CMD 26-H105.1A

Response from Orano Canada Inc. to Commission Request for Information

Application to renew the McClean Lake
Operating Licence for 2-year term

Re: Orano Canada Inc. – CMD 26-H105-Q – Orano’s Response to Questions from Commission Panel Members

Figure 1: Example of surface contamination from November 9, 2022

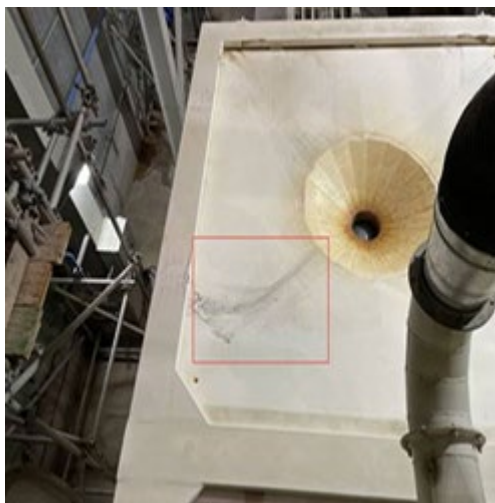
5. In CMD 26-H105.5, page 8 of 11, MN-S expresses concerns about transportation incidents, including those that involve slurry totes. Provide Orano's perspective on the transportation incidents and whether they have resulted in an impact on the environment, especially concerning sensitive ecosystems and associated biota, and people.

The transportation incidents involving slurry totes were all related to surface contamination on empty slurry totes returning to the Cigar Lake Operation (Figure 1), these incidents are rare and are typically the result of small droplets of diluted slurry on the top of the tote. It should be noted that the average rate of failure is 0.015% taking into consideration the number of trucks returning to the Cigar Lake Operation each day (18 trucks/day, 2 totes per truck). Each of the incidents were detected by Cigar Lake Operation personnel upon inspection of the empty totes once they are received. None of the incidents that have occurred resulted in exposure to the sensitive ecosystems and associated biota, and people.
